CITY OF ALBUQUERQUE

**Planning Department
Transportation Development Services**

**Re: The 377
2027 Yale Ave., SE
Traffic Circulation Layout
Engineer's/Architect's Stamp dated 6-9-15-15 (L15-D030)**

AS1.0

SITE PLAN / ROOF PLAN Scale: 1" = 10 FT 1

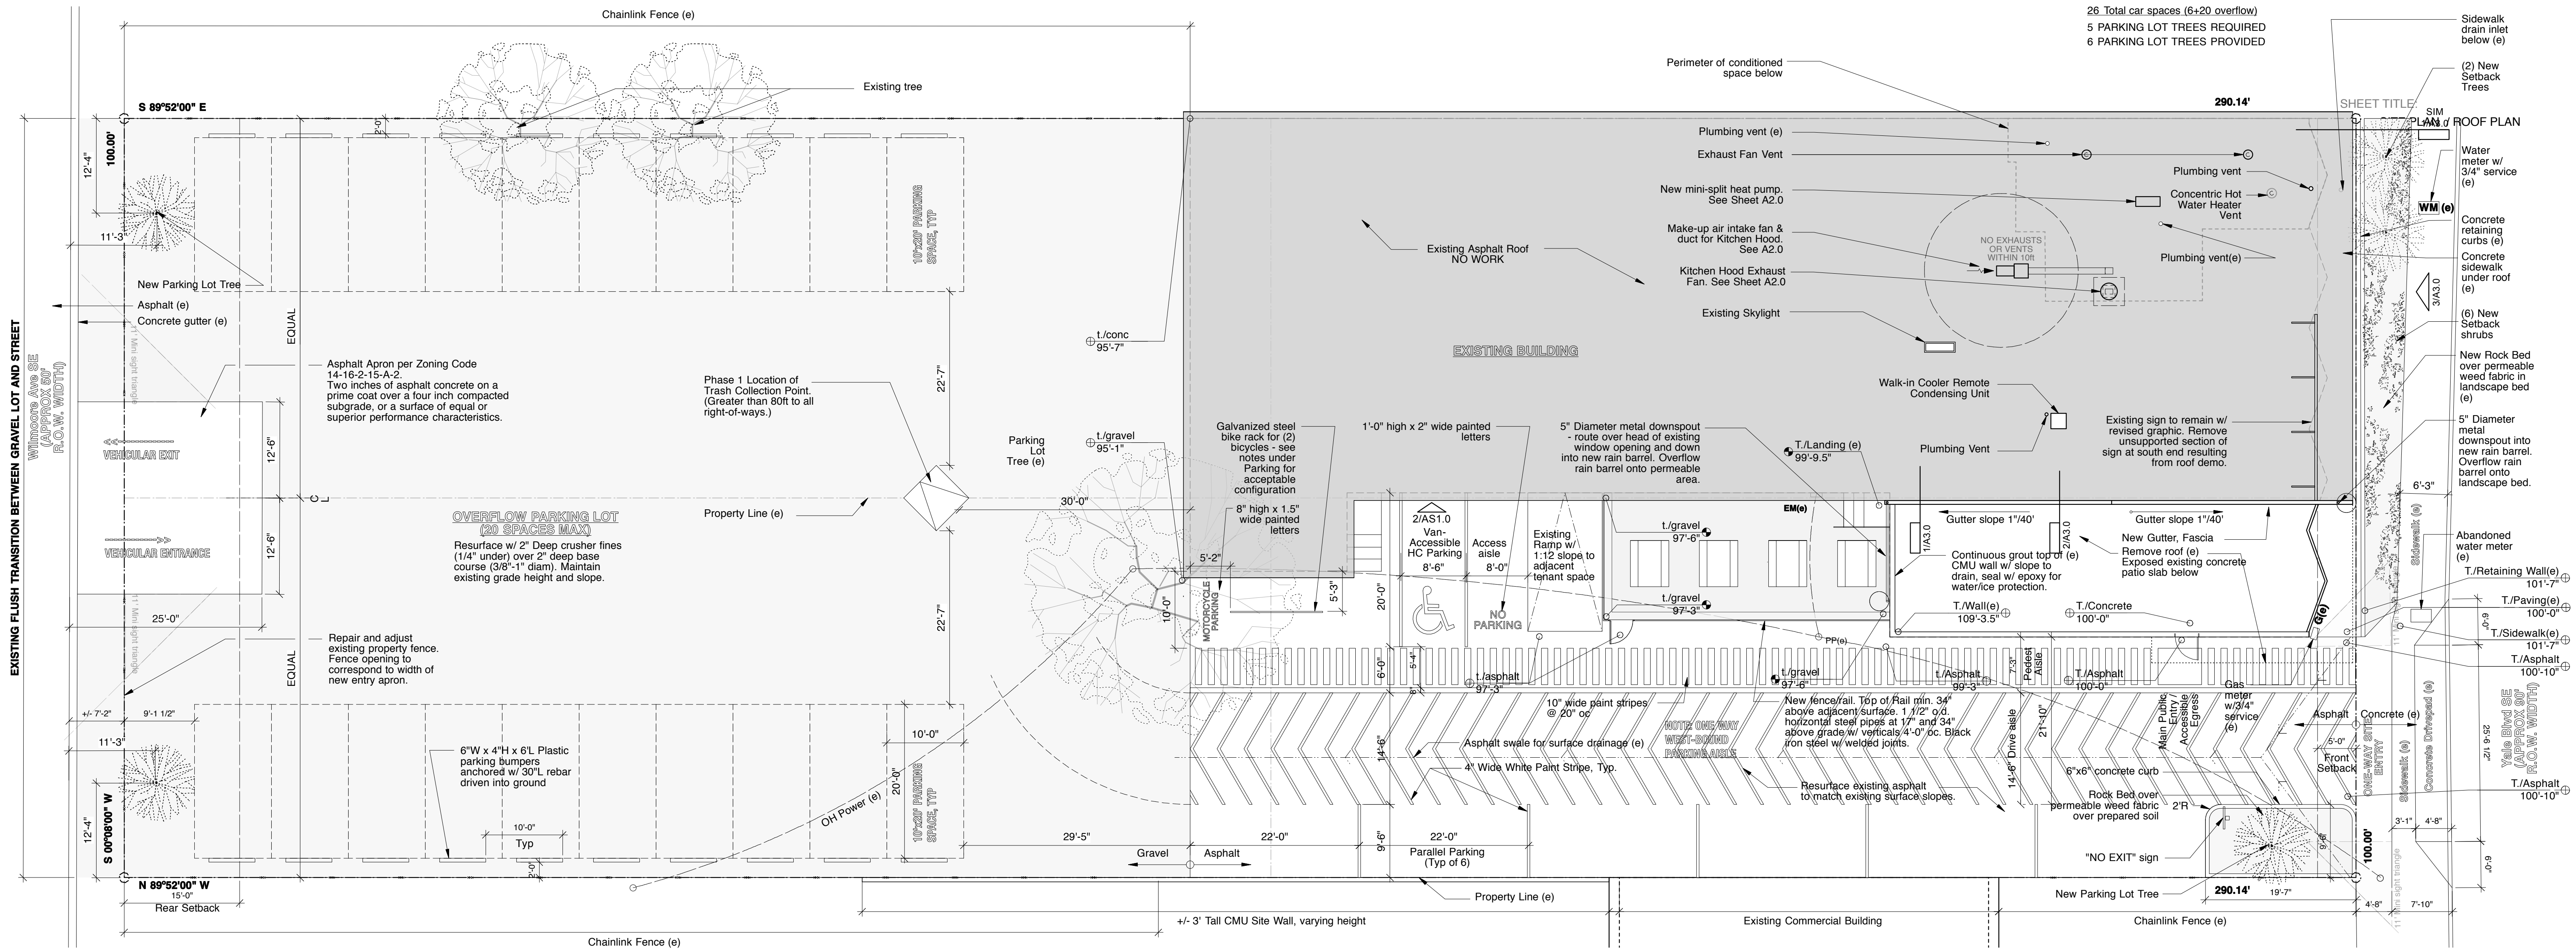
The TCL submittal received 6-10-15 is approved for Building Permit. A copy of the stamped and signed plan will be needed for each of the building permit plans. Please keep the original to be used for certification of the site for final C.O. for Transportation.
